MATANUSKA-SUSITNA BOROUGH

STAFF REVIEW AND RECOMMENDATIONS PUBLIC HEARING AUGUST 31, 2022

PRELIMINARY PLAT: SUSLOSITNA PLACE RSB BLOCK 1, LOT 3 & LOT 4

REQUEST: The request is to adjust the lot line between Lot 3 and Lot 4, Block 1, Suslositna Place, Plat No. 2021-117, to be known as **LOTS 3A and 4A**, containing 1.85 acres +/-. The parcel is located south of W. Schrock Road and south of N. Suslositna Street; within Section 21, Township 18 North, Range 01 West, Seward Meridian, Alaska.

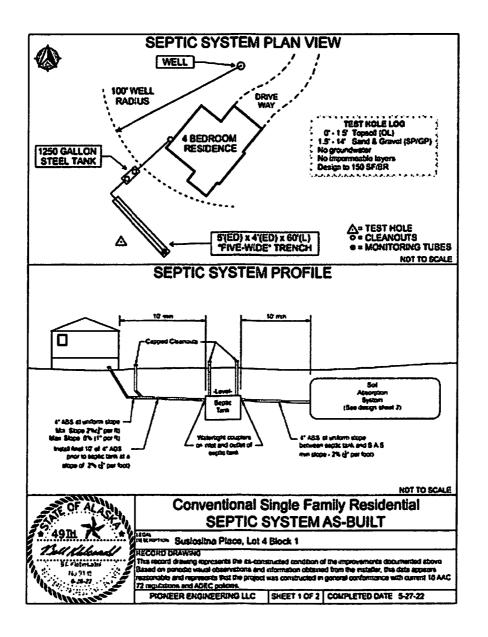
The test hole location map doesn't show the location of the test hole log that was included in the soils report.
